CHAPTER 2

Comments and Responses

IGR/CEQA Review
 Sis-5 & 265-Admin
 PacifiCorp Yreka-Weed Transmission Line Upgrade
 Mitigated Negative Declaration
 SCH# 2006092006

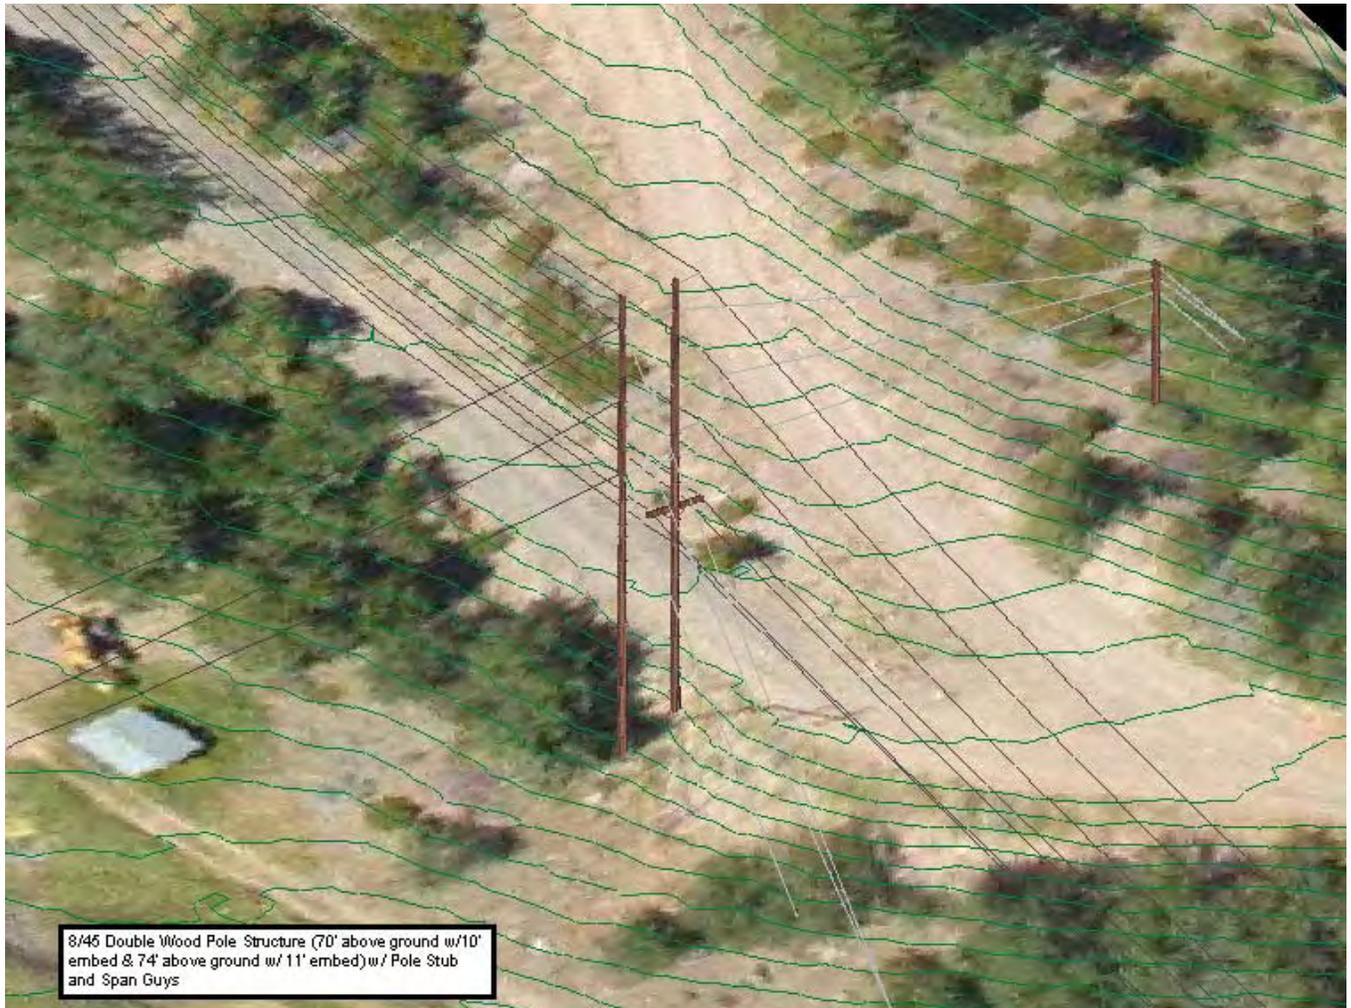
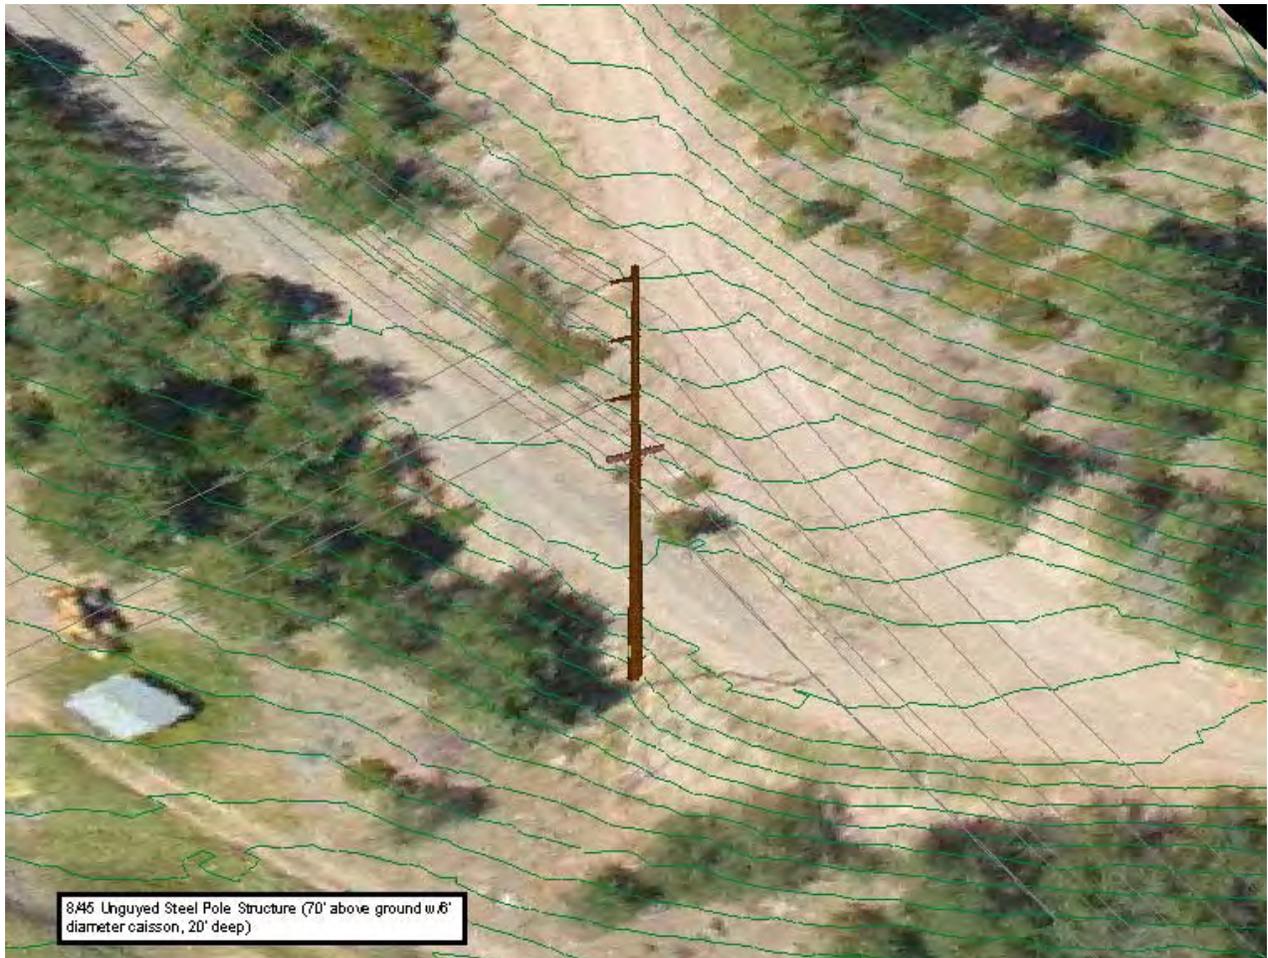
Data Request No. 2.7: Please provide a drawing or photograph showing the entire appearance of pole 8/45 and appendages thereto.

Response to Data Request No. 2.7: The options discussed in Responses to Data Requests 2.1 and 2.6 are preliminary designs. Once the design is finalized it will be outlined in detail. Below are perspective views showing each option.

Figure 2.4-3: Sand Hill Crane Nest and Mitigation Areas

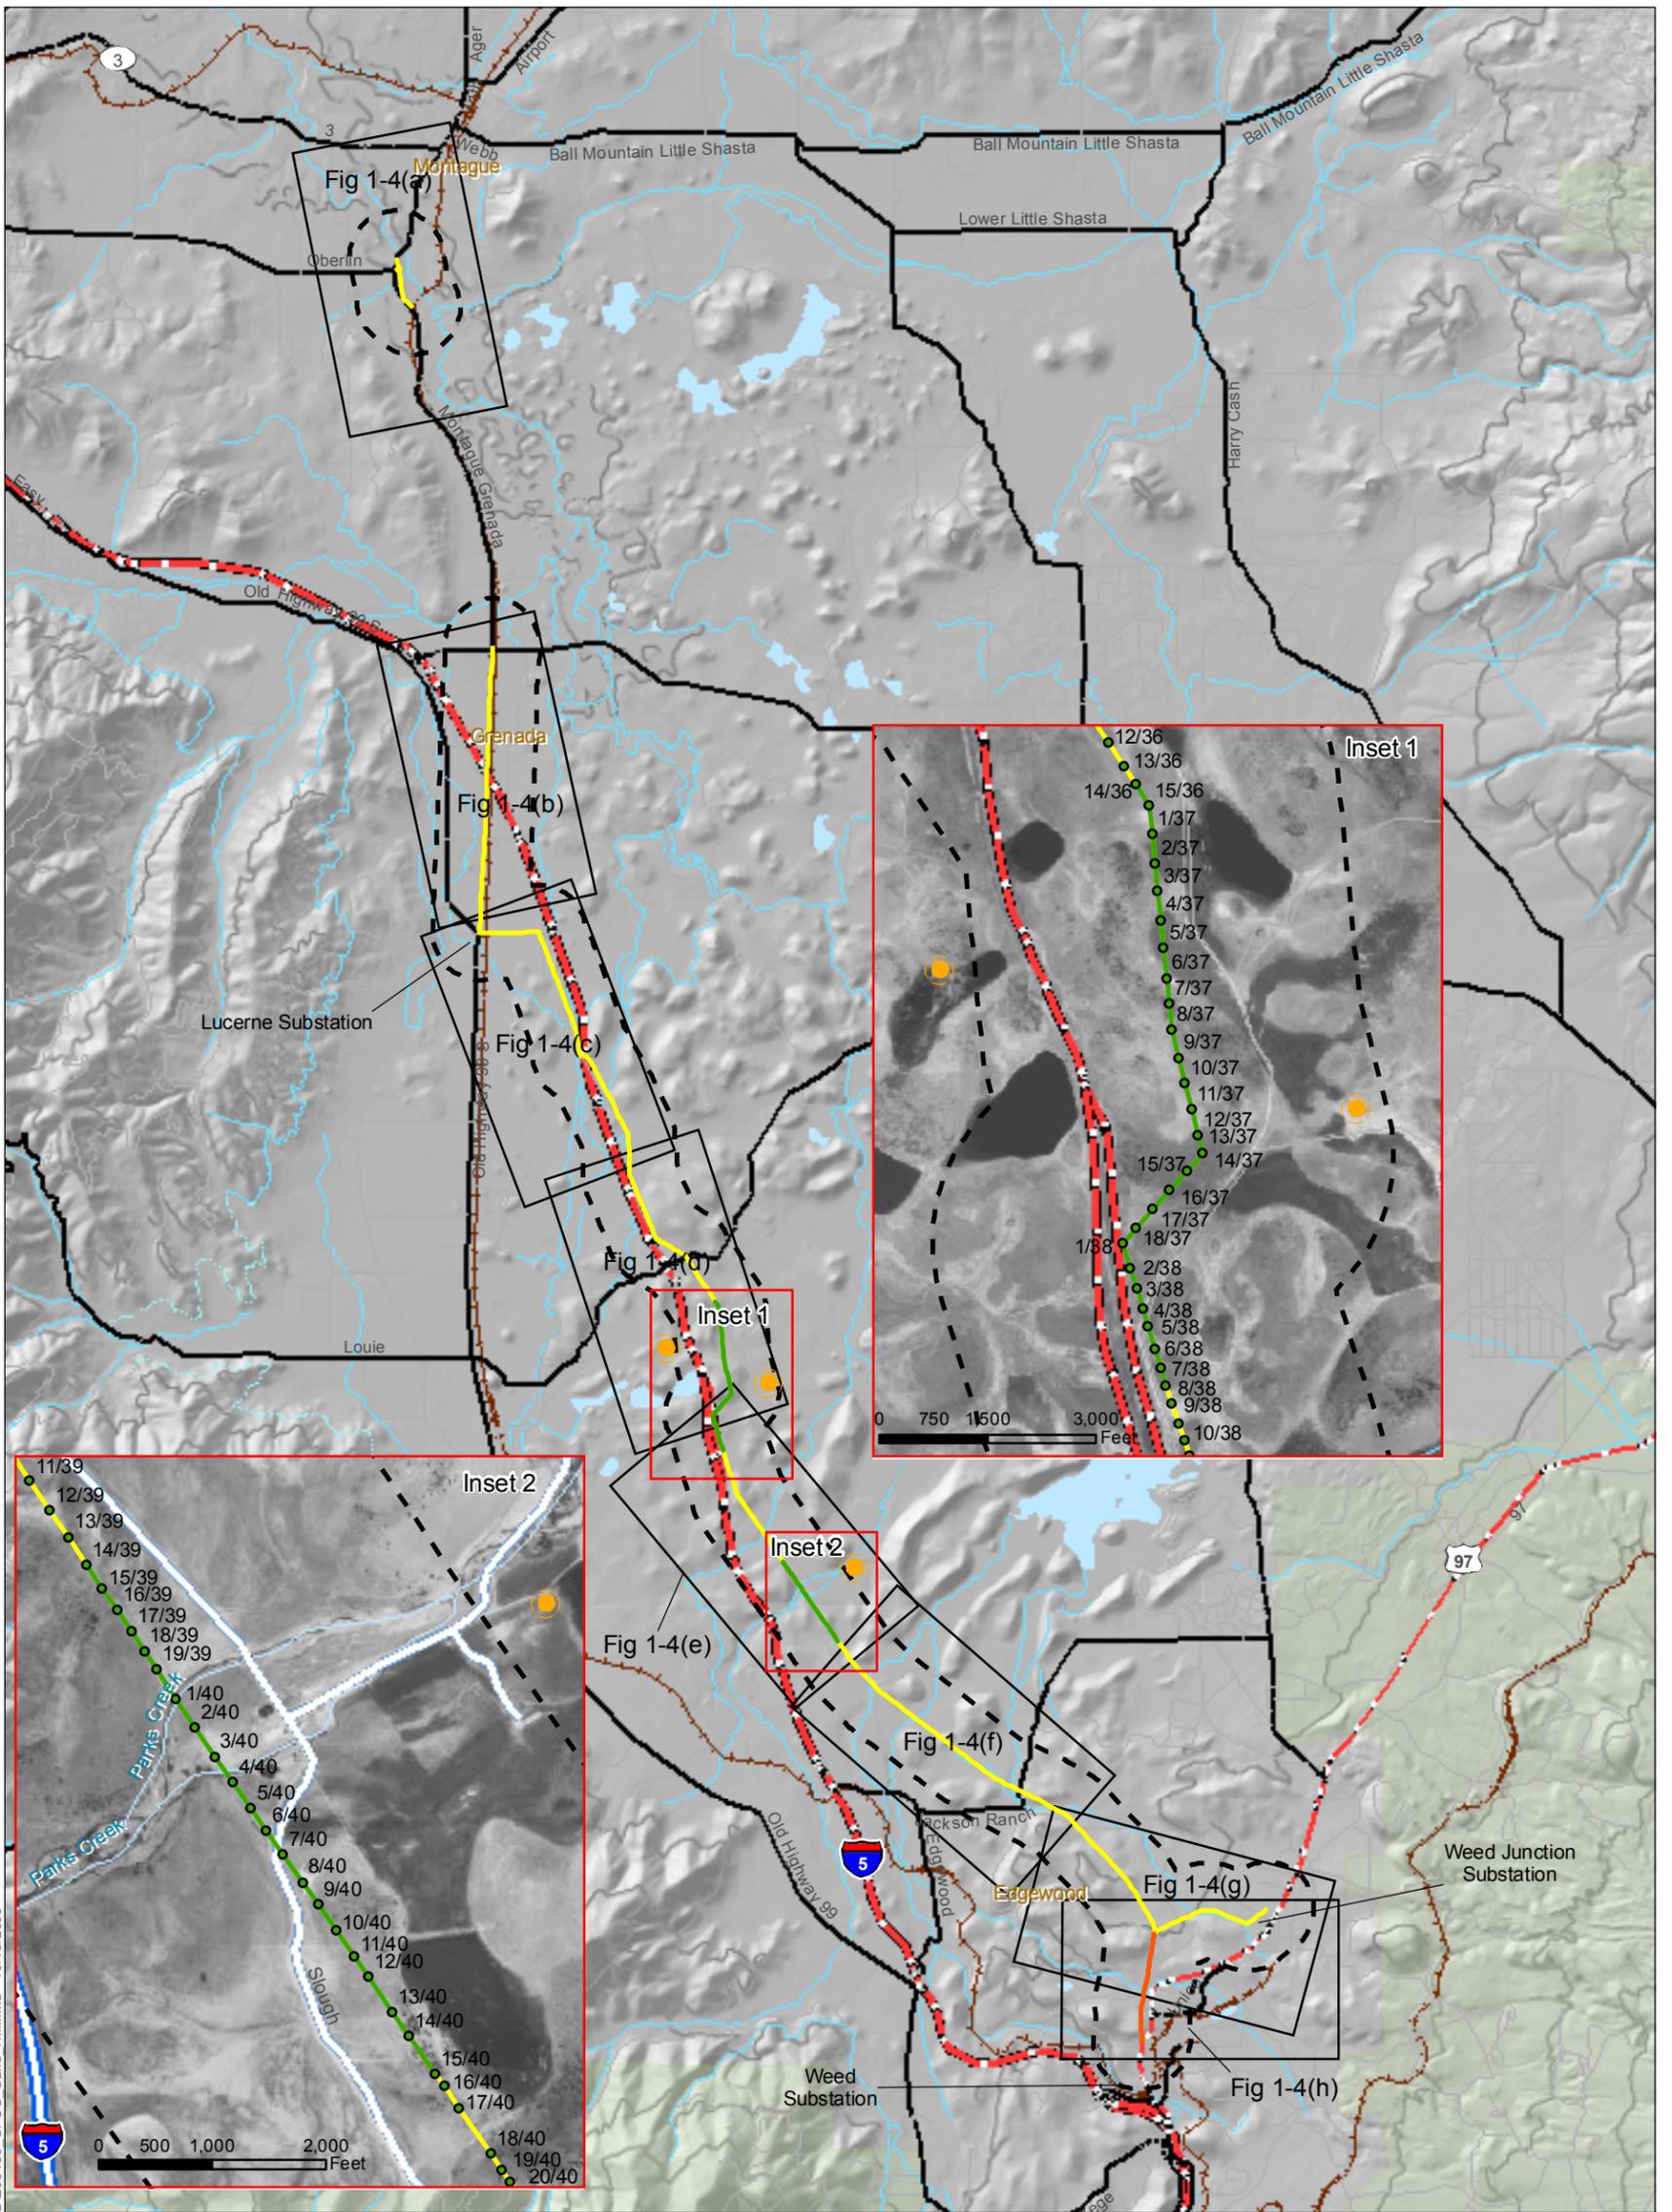
Another example of the lack of information relates to Swainson's Hawks. There is no discussion as to whether the species is prone to collisions with power transmission lines. The MND refers to Figure 2.4-3 for information about known nest locations. However, this figure is not in the document.

Mitigation Measure 2.4-8: PacifiCorp shall install warning markers (e.g., yellow aviation balls) on the upgraded transmission line one-half mile north and south of the point along the transmission line ROW closest to the known nests (i.e. Pole 14/36 south to Pole 8/38 and Pole 14/39 south to Pole 15/40). The known nests and recommended marker locations are shown in Figure 2.4-3. The specific marker type and

Note, although Figure 2.4-3, included within this document, was inadvertently left out of the MND; the information depicted was used in the analysis of impacts to sandhill crane.
